Appendices

Appendix C: Facility Reports for City Buildings and Parks

Appendix D: Facility Reports for Downtown Parking Lots

Appendix E: Public Rights-of-Way Reports for City Facilities and Schools

History Museum - Floor 2
One North San Antonio Road
Los Altos, CA

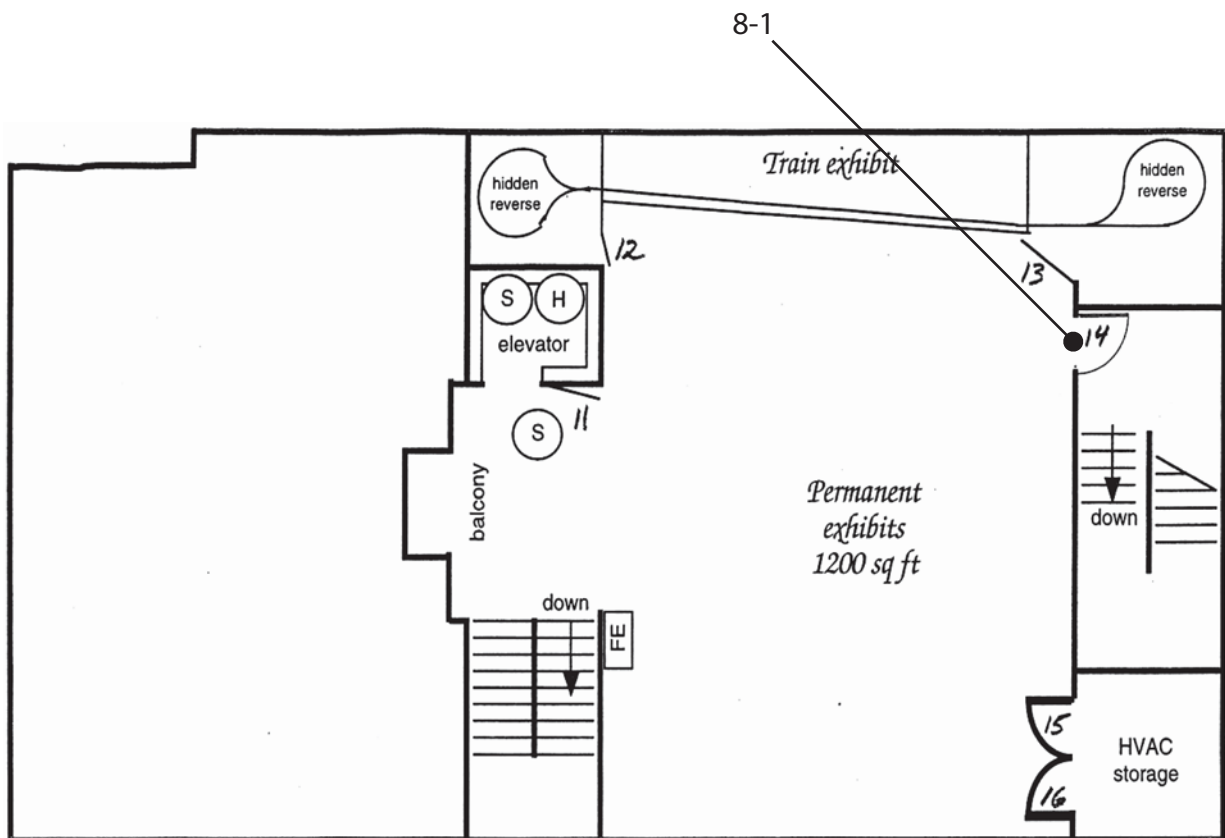
Floor 2		
8 - 1	Door/Gate	Priority: 2
Adjust door closer		\$250
Notes: Operating effort is 22lbs (5lbs max).		
State: 1133B.2.5		
Federal: 404.2.9

Los Altos Fire Station
10 Almond Avenue
Los Altos, CA

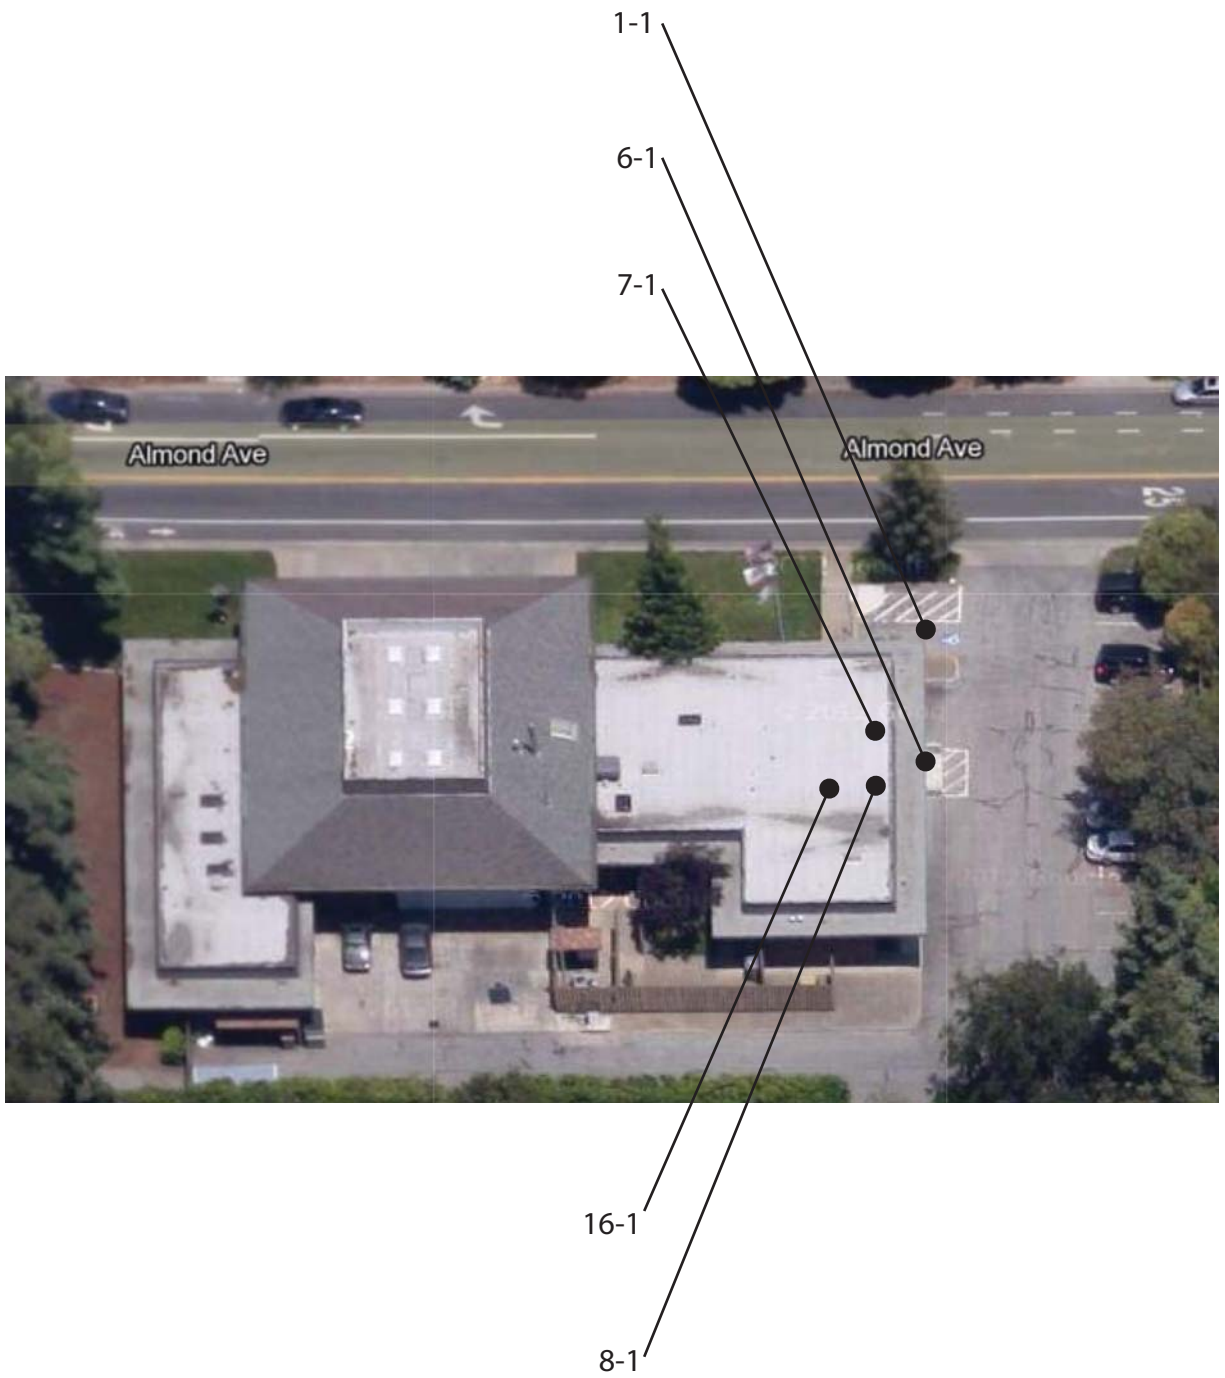
Exterior		
1 - 1	Parking Area	Priority: 1
Install sign		\$500
Notes:	No sign indicating "\$250 minimum fine"	
State:	1129B.4	
Federal:	-	
Install van parking sign		\$500
Notes:	Van sign is not provided.	
State:	-	
Federal:	208.2.4	
Provide or modify accessible access aisles		\$1,000
Notes:	There is a built up curb ramp in the access aisle. Slopes range from 2.1-5%. (2% max.). "No Parking" is not painted in the access aisle. The access aisle is not striped in blue.	
State:	1129B.3	
Federal:	-	
6 - 1	Stairway	Priority: 1
Install tread striping		\$50
Notes:	Indicator stripes are not provided. There are three risers.	
State:	1133B.4.4	
Federal:	-	
7 - 1	Hazard	Priority: 1
Remove overhanging or protruding objects		\$1,000
Notes:	Emergency phone is a protruding object. Phone protrudes 8" from the wall (4" max.) and is located 40" above the ground surface (less than 27", greater than 80" req.)	
State:	1133B.8.6	
Federal:	307.2

Floor 1		
8 - 1	Door/Gate	Priority: 1
Provide sign(s) indicating accessible entries and facilities		\$100
Notes: Primary entrance is not marked with the International Symbol of Accessibility.		
State: 1117B.5.8.1.2		
Federal: 216.6, 703.7.2.1		
16 - 1	Built-in Elements	Priority: 2
Provide an accessible counter		\$5,000
Notes: Counter height is 42" AFF (btwn. 28-34" req.)		
State: 1122B.4		
Federal: -

Main Library
 13 South San Antonio Road
 Los Altos, CA

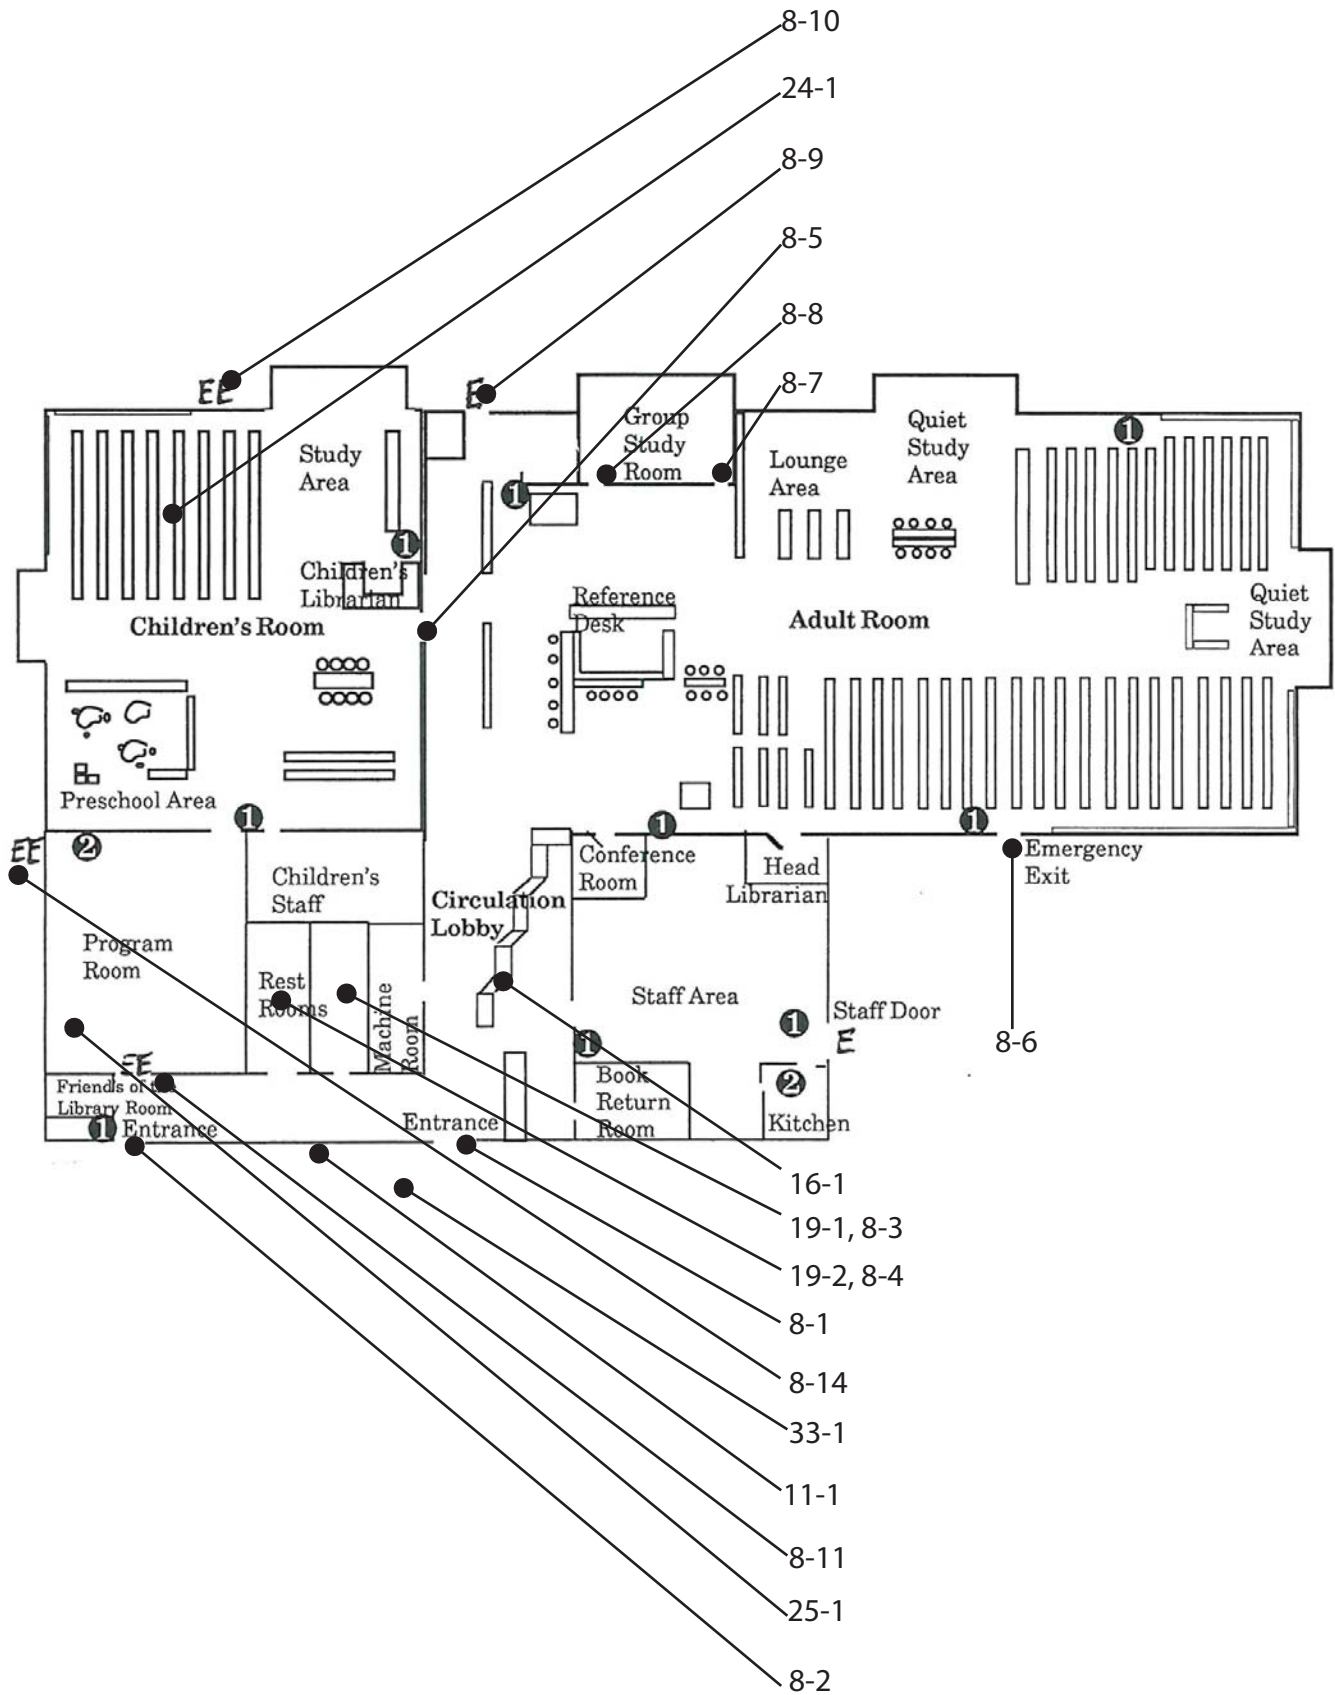
Exterior		
11 - 1	Telephone	Priority: 3
Increase or provide maneuvering or clear floor area		\$2,000
Notes: Clear floor space provided is 32x38" (30x48"min.)		
State: 1117B.2.2		
Federal: 305.3, 704.2.1		
Provide new phone equipment		\$0
Notes: Heigh of coin slot is 54" (48" max.)		
State: -		
Federal: 308.3		
33 - 1	Outdoor Constructed Features	Priority: 3
Provide accessible fixed bench		\$2,000
Notes: Clear ground space near benches exceed 2%.		
State: -		
Federal: AGODA 1011.2.2

25 - 1	Kitchen	Priority: 2
Modify lavatory/counter clearances		\$2,500
Notes: Height of kitchen counter is 36" AFF (34" max.) Knee space is not provided under lavatory. Depth of sink is 7-1/2" (6-1/2" max.)		
State: 1117B.9		
Federal: 804.4		
Replace or reposition dispensers or mirrors		\$150
Notes: Paper towel dispenser is 46" AFF (40" max.)		
State: -		
Federal: 308

Police Station
One North San Antonio Road
Los Altos, CA

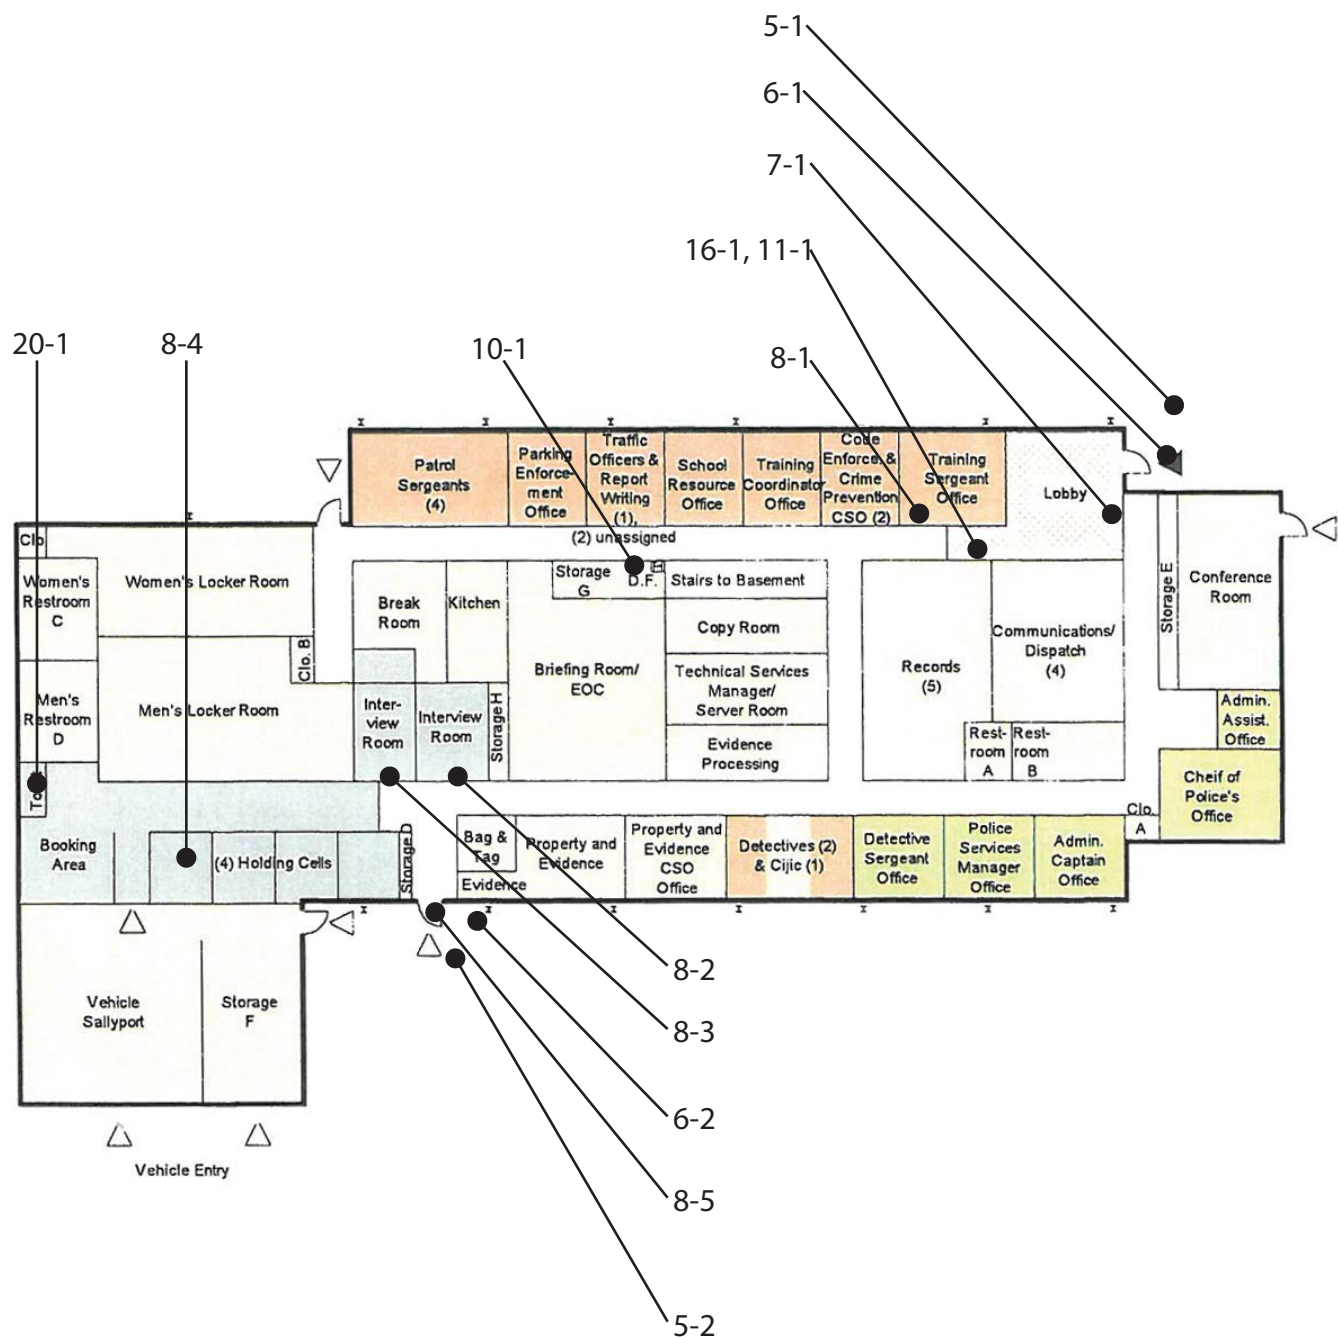
Exterior		
5 - 1	Ramp	Priority: 1
Install or modify handrails		\$5,000
Notes: Handrail is provided on one side of the ramp. Handrail does not return to to post or ground surface. Top extension of handrail is 9" and bottom extension is 2" (12" min.) Ramp is 26'-0" long.		
State: 1133B.5.5.1		
Federal: 405.8, 505.10.1		
Provide level landing		\$5,000
Notes: Intermediate landing is 49" x 49" (60" x60" min.)		
State: 1133B.5.4.6		
Federal: -		
5 - 2	Ramp	Priority: 1
Regrade or replace ramp		\$25,000
Notes: Ramp slope is 17%. Handrails are not provided.		
State: 1133B.5.3, 1133B.5.3.1		
Federal: 405.2, 405.3		
6 - 1	Stairway	Priority: 1
Install tread striping		\$75
Notes: Indicator stripes are not provide. Three risers.		
State: 1133B.4.4		
Federal: -		
6 - 2	Stairway	Priority: 1
Install tread striping		\$100
Notes: Indicator strips are not provided.		
State: 1133B.4.4		
Federal: -		
Install or modify handrails		\$5,000

Floor 1		
20 - 1	Single User Restroom	Priority: 2
Replace or modify grab bars		\$1,000
Notes: Grab bars are not provided in the single user restroom.		
State: 1115.7, 1115B.4.1.3, 1115B.7		
Federal: 1115B.4.1.3, 604.5.1, 609, 609.3, 609.5, 609.6, 609.8		
Increase or provide maneuvering or clear floor area		\$2,000
Notes: A 60" turn around space is not provided.		
State: 1115B.3.2.2		
Federal: 603.2.1		
Replace toilet or adjust toilet seat height		\$1,000
Notes: Toilet seat height is 13-1/2" (17-19" req.)		
State: 1115B.4.1.5		
Federal: 604.4

San Antonio Club - Tiny Tots
647 South San Antonio Road
Los Altos, CA

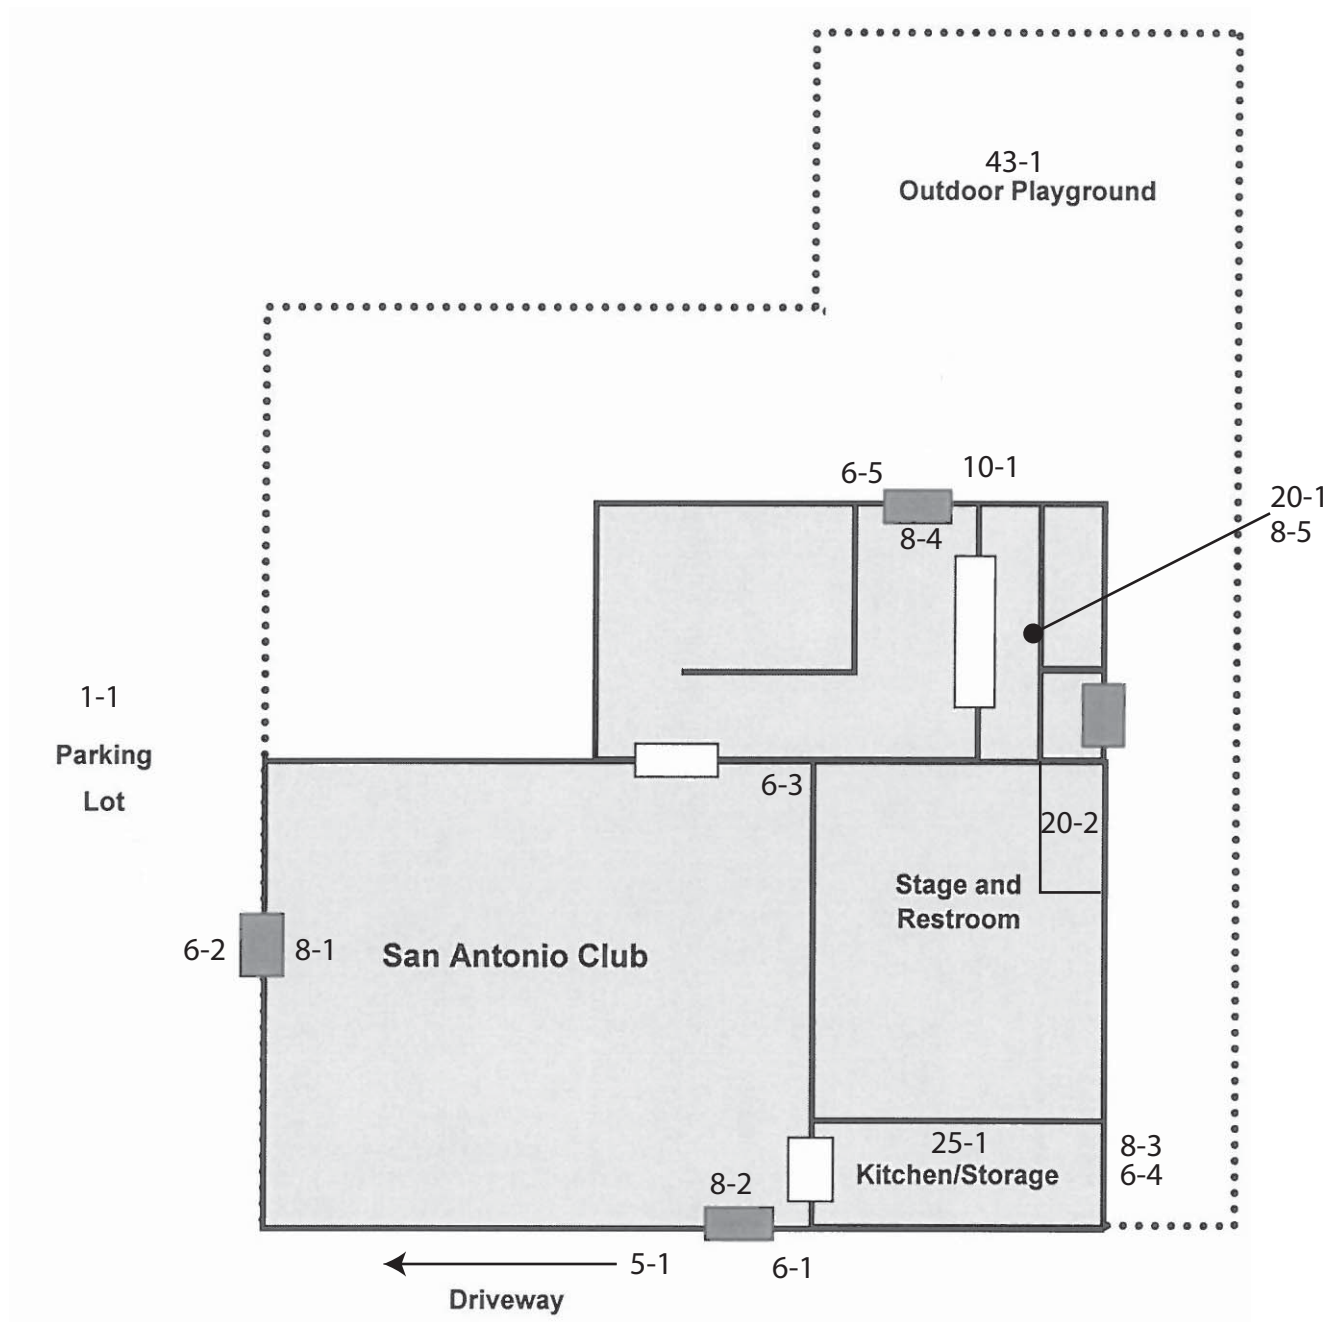
Exterior		
1 - 1	Parking Area	Priority: 1
Install van parking sign		\$500
Notes: Van signage is not provided.		
State: -		
Federal: 208.2.4		
Install sign for unauthorized parking		\$500
Notes: Warning sign is not provided at the entrance of the parking lot or at each individual accessible space.		
State: 1129B.4		
Federal: -		
Install sign		\$500
Notes: "Minimum fine \$250" signage is not provided.		
State: 1129B.4		
Federal: -		
Provide or modify accessible spaces		\$500
Notes: Access aisles are not striped in blue.		
State: 1129B.4		
Federal: -		
5 - 1	Ramp	Priority: 1
Install or modify handrails		\$5,000
Notes: Handrail is located on one side of ramp. Both sides required.		
State: 1133B.5.5.1		
Federal: 405.8		
6 - 1	Stairway	Priority: 1
Install or modify handrails		\$5,000
Notes: Handrails for stairs are provided on one side only. There is no bottom extension (12" min. + one stair tread req.)		
State: 1133B.4.2.2, 1133B4.1.1

Floor 1		
25 - 1	Kitchen	Priority: 2
Increase or provide maneuvering or clear floor area		\$2,000
Notes: Kitchen area has a turn around space of 25-26" (60" min.)		
State: 1117B.9		
Federal: -		
Replace or reposition dispensers or mirrors		\$150
Notes: Paper towel dispenser is mounted 51-1/2" AFF (40" max.)		
State: -		
Federal: 308		
Provide an accessible counter		\$5,000
Notes: Countertop is located 36-1/2" AFF (34" max.)		
State: -		
Federal: 804.3.2		
Modify lavatory/counter clearances		\$2,500
Notes: Knee and toe clearance is not provided under the sink. Sink depth is 8-1/2" (6-1/2" max.)		
State: 1117B.9		
Federal: -		
43 - 1	Play Equipment Area	Priority: 2
Ground surface safety and accessibility		\$100
Notes: Redistribute engineered wood fiber in play area to provide even surface.		
State: -		
Federal: 1008.2.6.1, 1008.2.6.2
